IN THE DRAWINGS:

REMARKS/ARGUMENTS

The Office Action mailed June 7, 2006, has been received and reviewed. Claims 1 through 40 are currently pending in the application. Claims 4 through 6, 11, 12, 14 through 19, and 26 through 39 are withdrawn from consideration as being drawn to non-elected invention(s). Claims 1 through 3, 7 through 10, 13, 20 through 25, and 40 stand rejected.

FIG. 6A

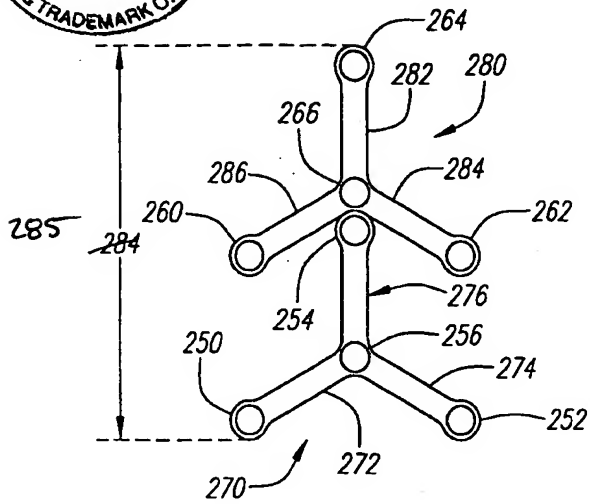
The attached sheets of drawings include changes to FIGS. 6A, 9D and 11B. These sheets, which include FIGS. 6A-6D, 7; 9A-9F; and 10A-10C, 11A and 11B, replace all previous drawing sheets submitted for these figures. In FIG. 6A, distance line "284" has been changed to --285--; FIG. 9D has been revised to change reference numeral 494 (second occurrence) to 496; and FIG. 11B has been revised to change reference numerals 596 (four occurrences) to 597 and reference numeral 594 (second occurrence) to 596. (See attached Replacement Sheet(s) and Annotated Sheet(s) Showing Changes.)
